PUBLIC UTILITIES COMMISSION OF THE STATE OF CALIFORNIA

SAFETY DIVISION
UTILITIES SAFETY BRANCHRESOLUTION SU-1*
April 26, 1989**R E S O L U T I O N****ORDER AUTHORIZING LOS ANGELES COUNTY TRANSPORTATION
COMMISSION TO DEVIATE FROM RULE 37 OF GENERAL ORDER NO.
95 RELATING TO GROUND CLEARANCE OF TROLLEY CONTACT WIRES**

APPENDIX A (SHEET 2 OF 2)

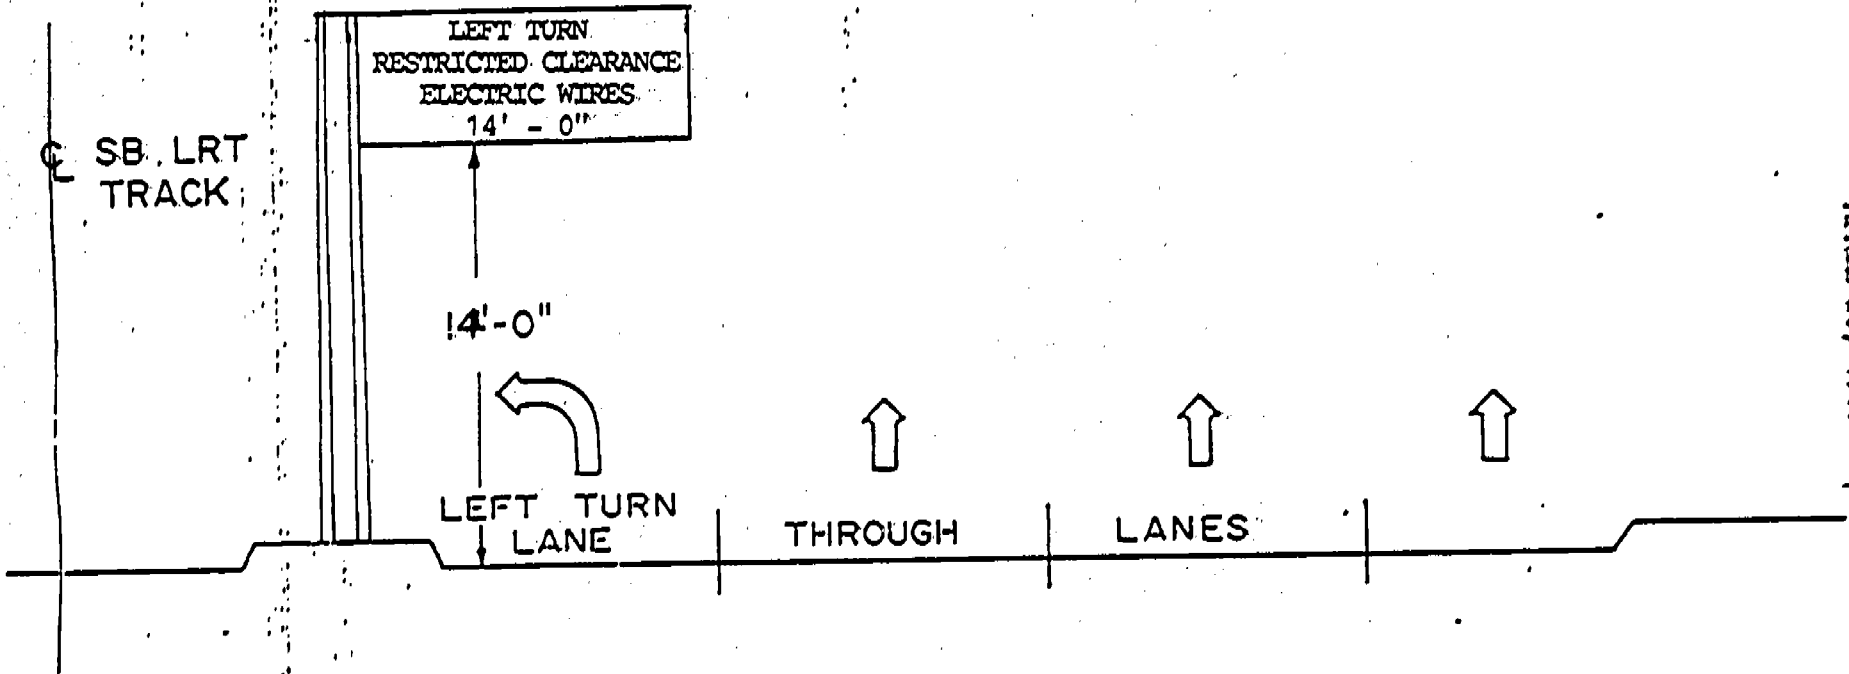
3. Flower Street is one-way southbound and cannot be lowered without incurring major design changes and expenses.
4. A left turn sign will be installed ahead of the driveway at Location A. The clearance of the sign above the pavement will be 14' - 0" and it will read, "Left Turn Restricted Clearance Electric Wires 14' - 0"" (See Appendix A, Sheet 2).

1. LACTC is authorized to deviate from Rule 37 of General Order No. 95 to install the trolley contact wires at Locations A, B and C as shown in Appendix A, Sheet 1, with clearances above pavement of 14' - 9", 14' - 6" and 16' - 8" respectively.
2. As a condition for this deviation, LACTC will install and maintain an overhead sign at Location A reading "Left Turn Restricted Clearance Electric Wires 14' - 0"" with a clearance of 14' - 0" above the pavement.
